Local Traffic Committee Meeting

Venue	Conference Room, Station Street, Mullumbimby
Date	Tuesday, 3 June 2025
Time	9:00 AM

Report No. 6.1 Intersection upgrade at 189 Federal Drive

www.brs.com.au
mail@brs.com.au
ABN: 25 134 067 842
980225

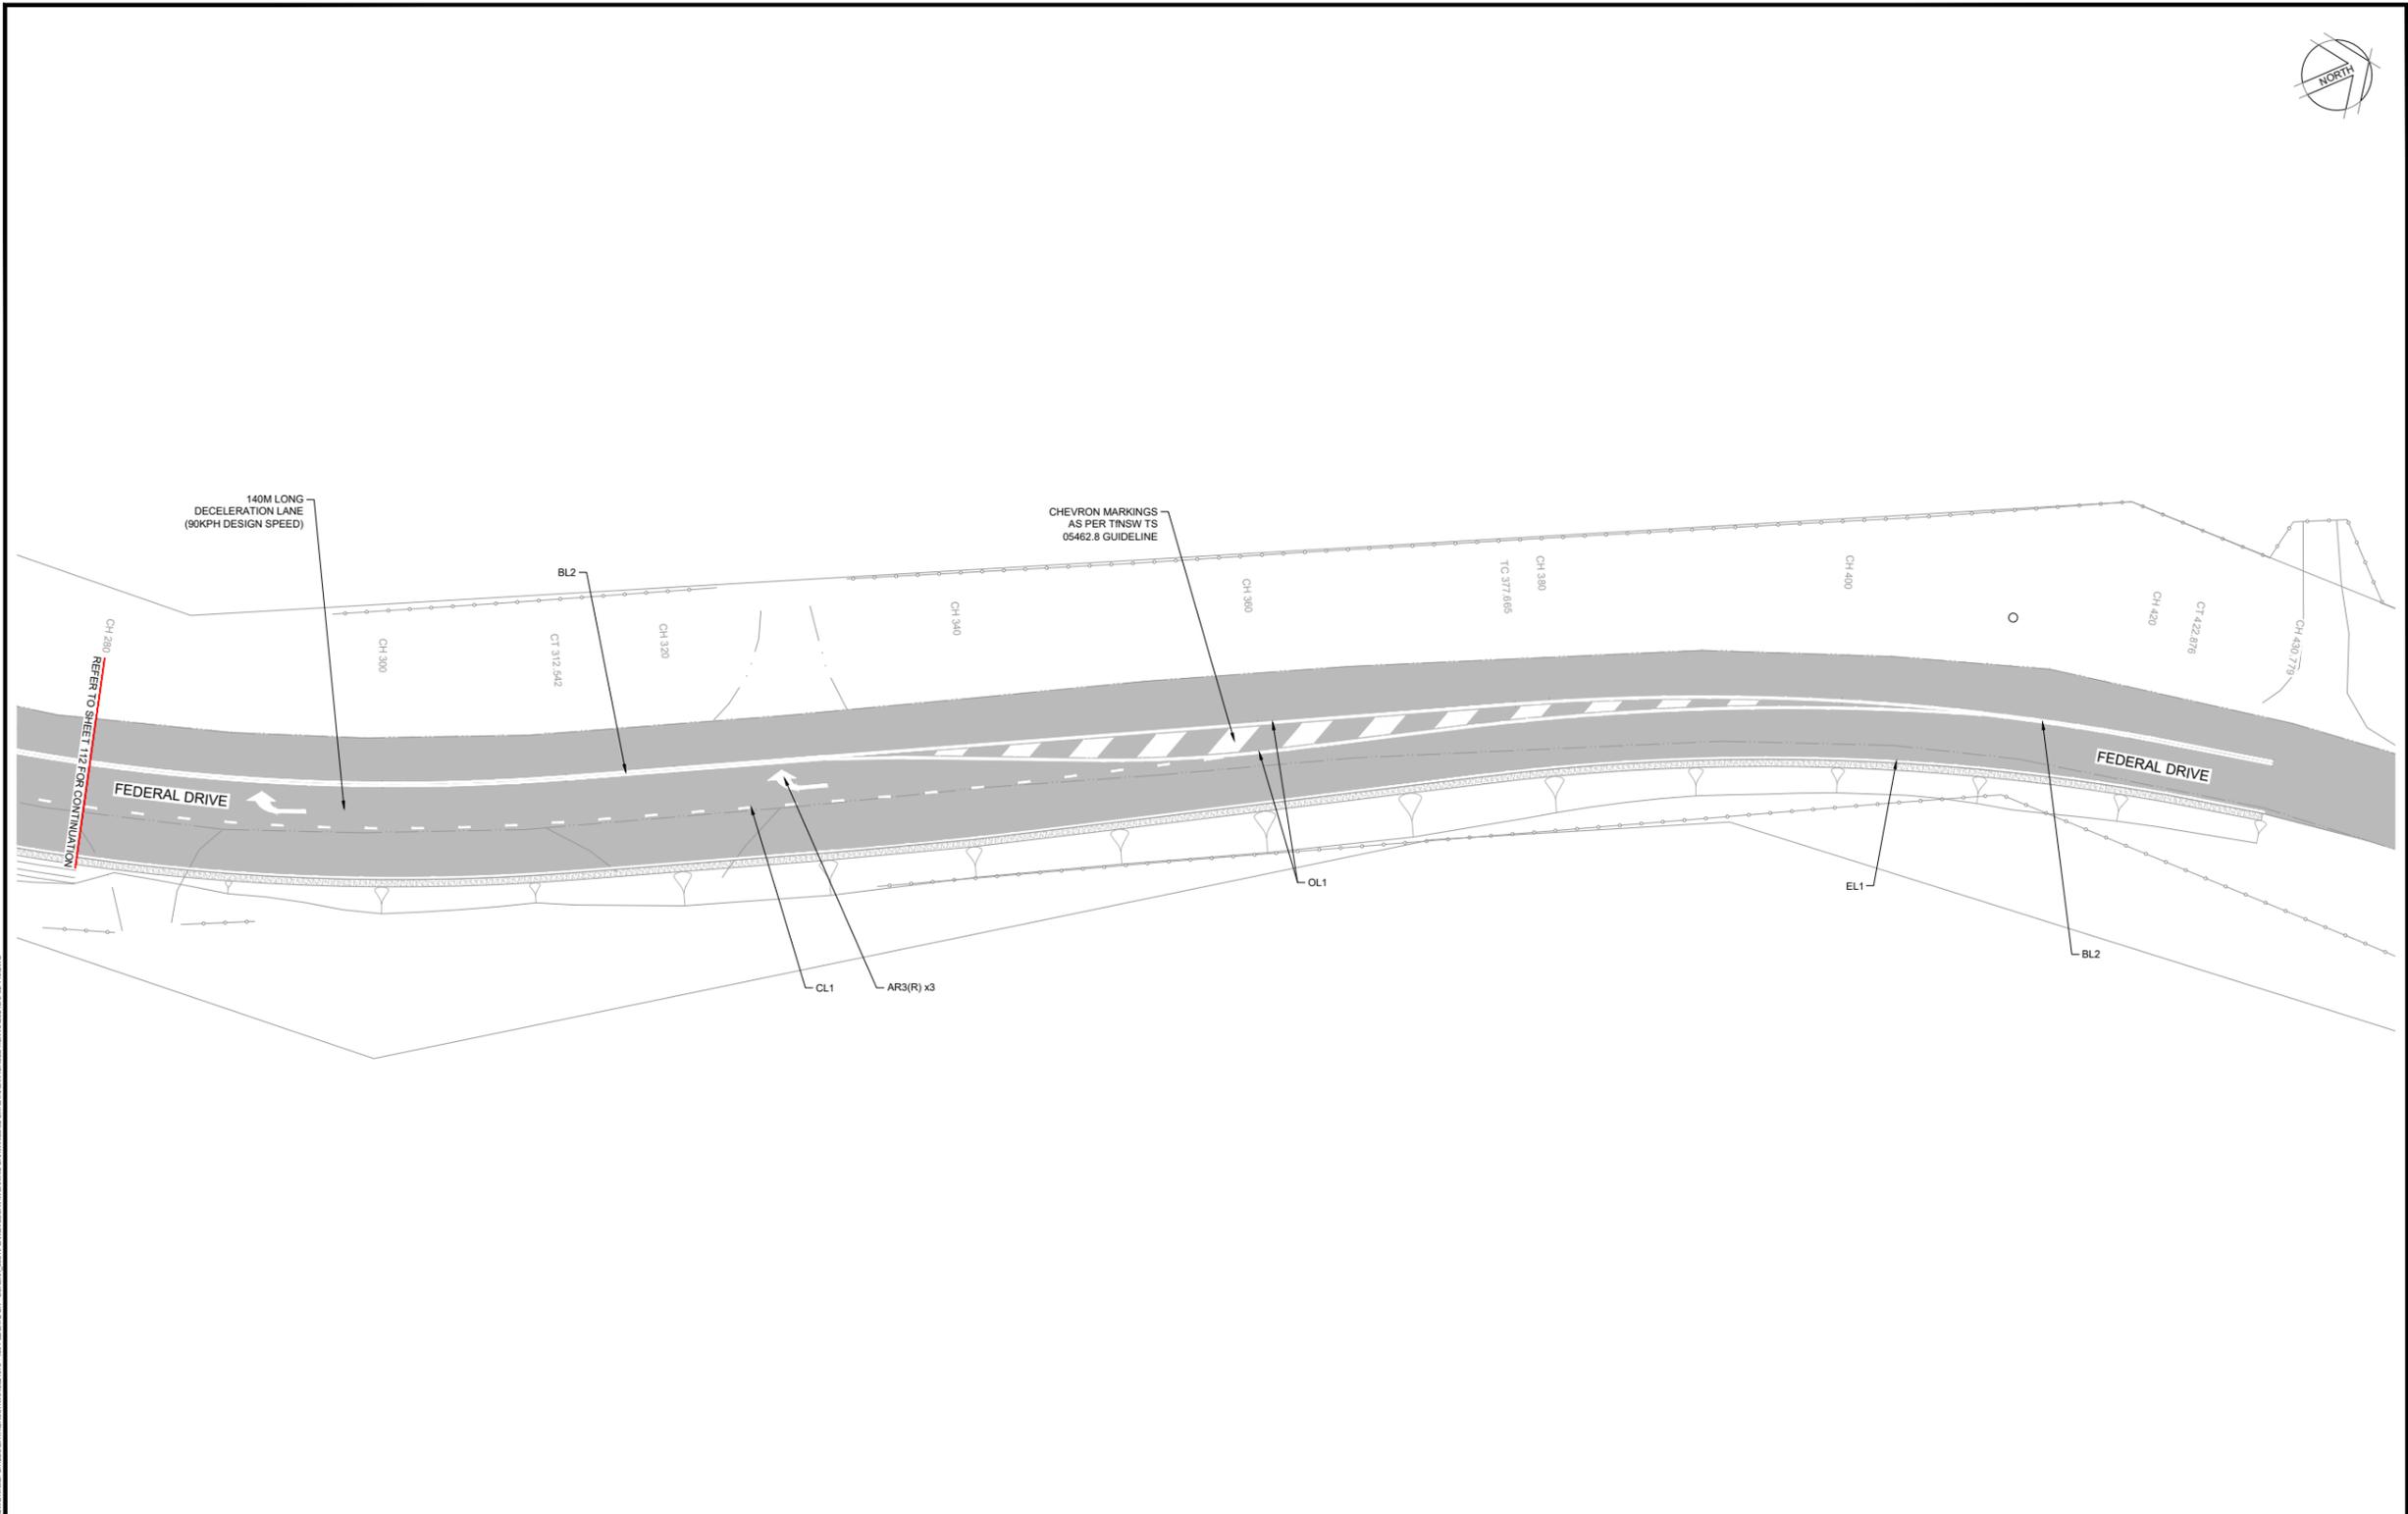
The following changes and requirements must be adopted into the modified seagull intersection design:

- Travel lane at 3.5m.
- Auxiliary lane at 3.0m
- Length of seagull painted island at 70m
- Width of seagull painted island at 3.5m
- Flag lighting in accordance with AS1158
- Acceleration lanes, deceleration lanes, painted medians, right turns, left turns but not limited to in accordance with Austroads Guide to Road Design
- Design speed of 90kph
- The seagull treatment must be supported with a swept path analysis plan to cater for a standard side loading refuse collection vehicle (RCV) specified in Chapter B8 of Council's BDCP coming from all directions. The RCV must enter and exit in forward direction.

Note: the supporting swept path analysis plan did not include maneuvering coming from the north and exiting heading south

That the Local Traffic Committee endorses the proposed intersection plan as nominated in Attachment 1 (E2025/51169).
